March 30, 2020

We appreciate the State has its hands full at the moment. At the same time, preparations continue for completing the Governor Mario M. Cuomo Bridge's walking/cycling path. Thus, we bring this to your attention now so it can be addressed at the right time.

We viewed the beautiful “flyover” video of the Shared-Use Path (<https://youtu.be/15HwNctJJsY>). While we realize this rendering is for promotional purposes, it contains details that – if implemented as shown – will cause difficulty.

SETBACKS

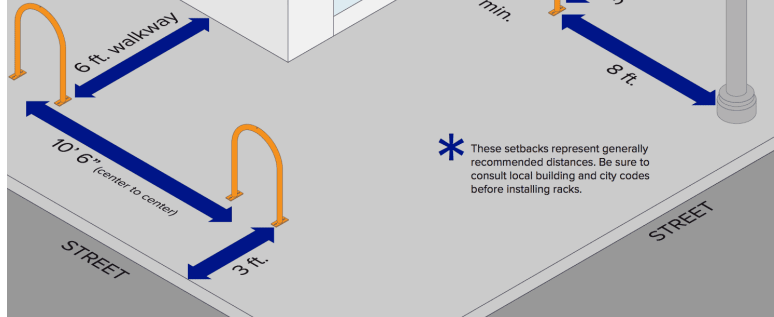
3) The Rockland Welcome Center rendering includes inverted U racks for parking bicycles. These are excellent. Their placement may need refinement, though. The racks look like they will be too close together and be up against shrubs (see screen capture, right). There needs to be at least 3 feet between each rack and 2 feet away from obstructions in front of them (see diagram below our signatures). This allows easy access for people to lock bikes to both sides of each rack.

Follow these recommended setbacks when installing racks near walls, streets, infrastructure, or other bike racks.
